Addendum No. 3

Project Name: NECSD – New CTE Building

CSArch Project No. 108-2303

Sheet No. CTE
A201

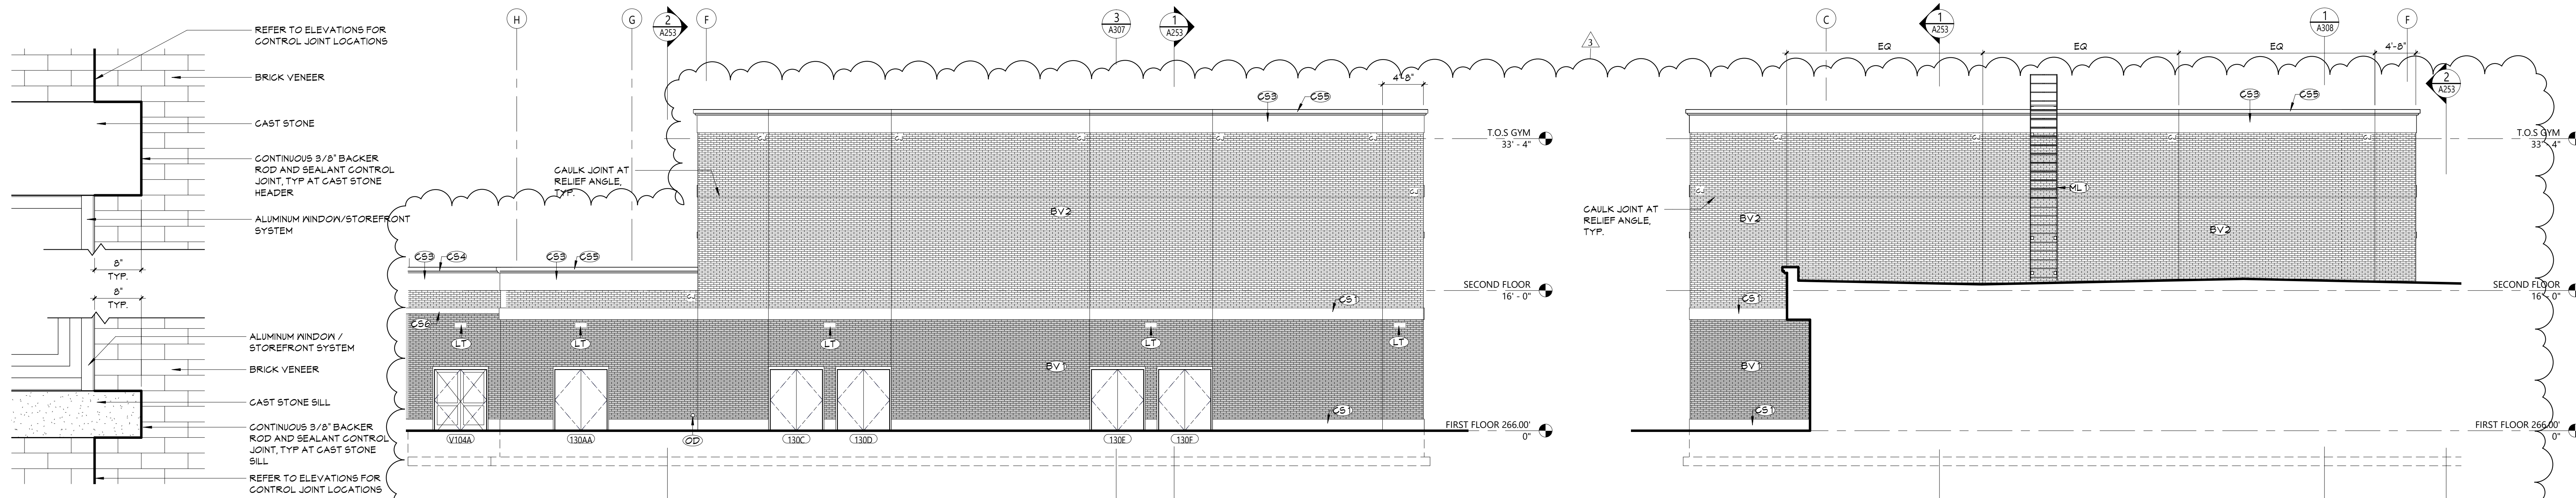
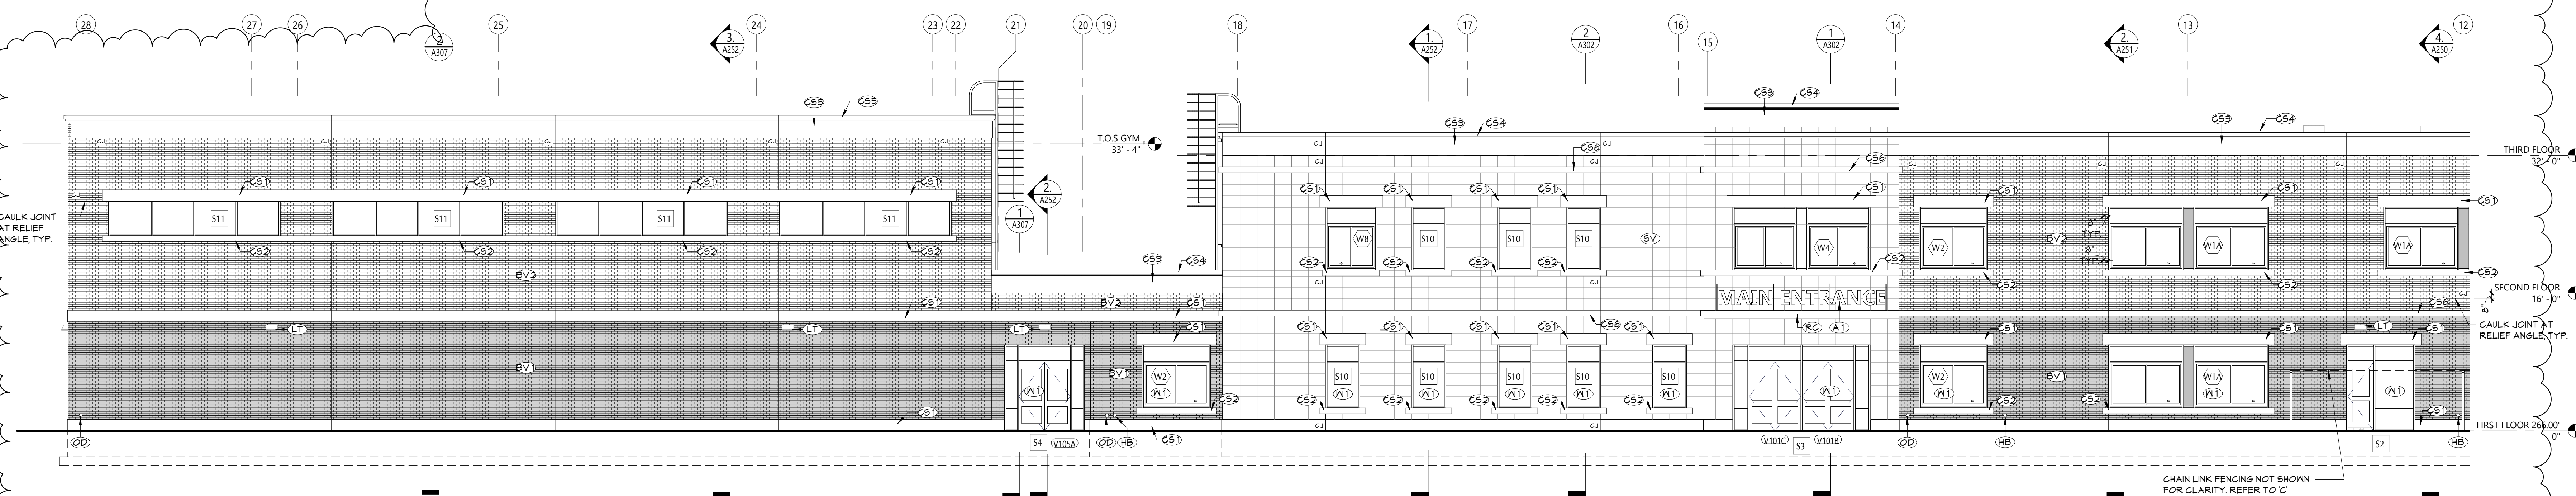
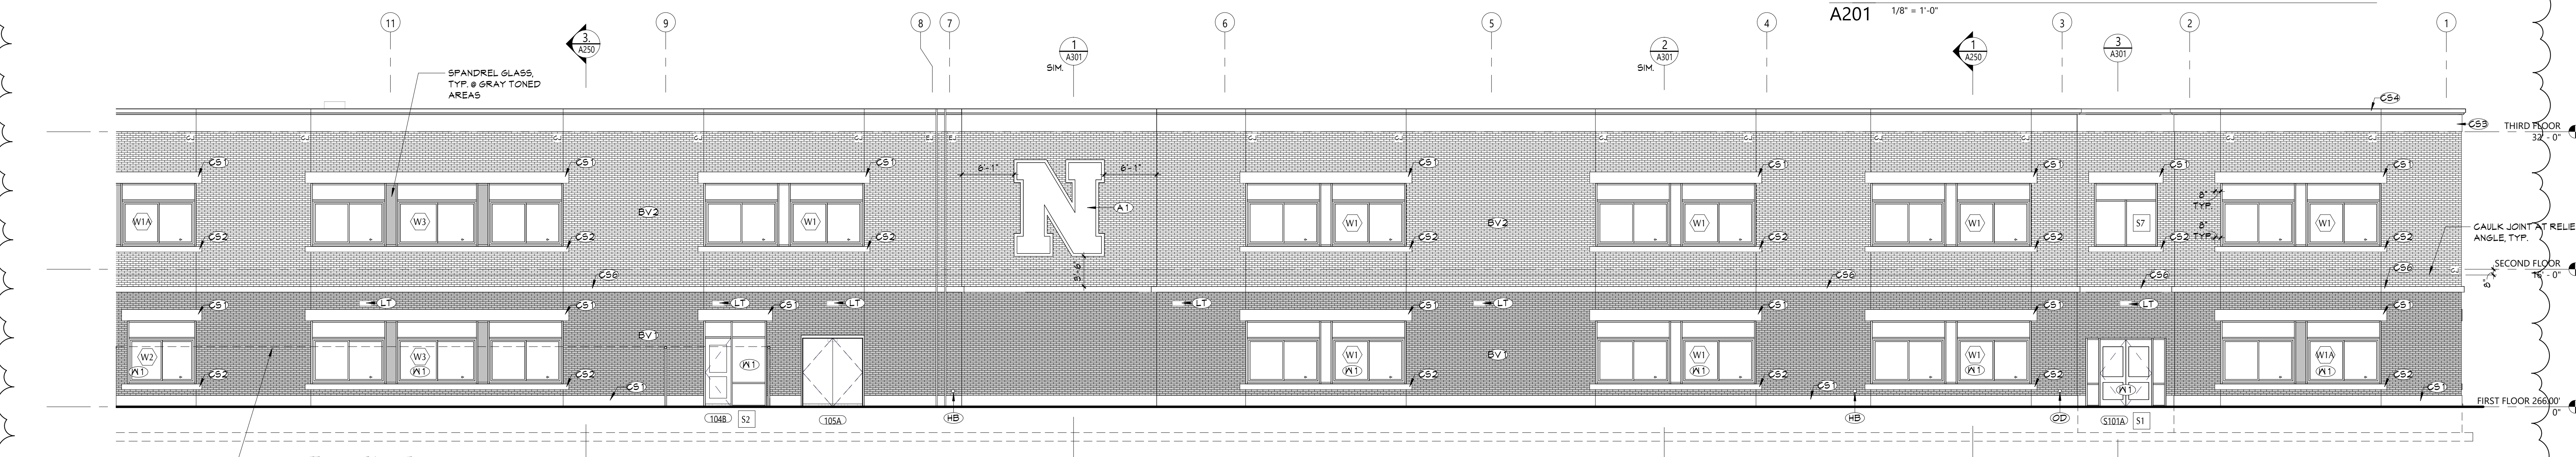
| 64 | A | Cast Stone | Please clarify cast stone profiles locations. For instance: Dr.A201 /4 elevation shown second floor cast stone profile CS3 & CS4 Building Section dr. A307/3 shows CS1. Elevation dr. A201/2 shows CS3 building section shows CS2. And there are more discrepancies. | 5/10/2024 | Worth Construction Co., Inc. | Revised as part of addendum #3. | Yes | A201, A202, A203, A204, A205 | | Add #3 |
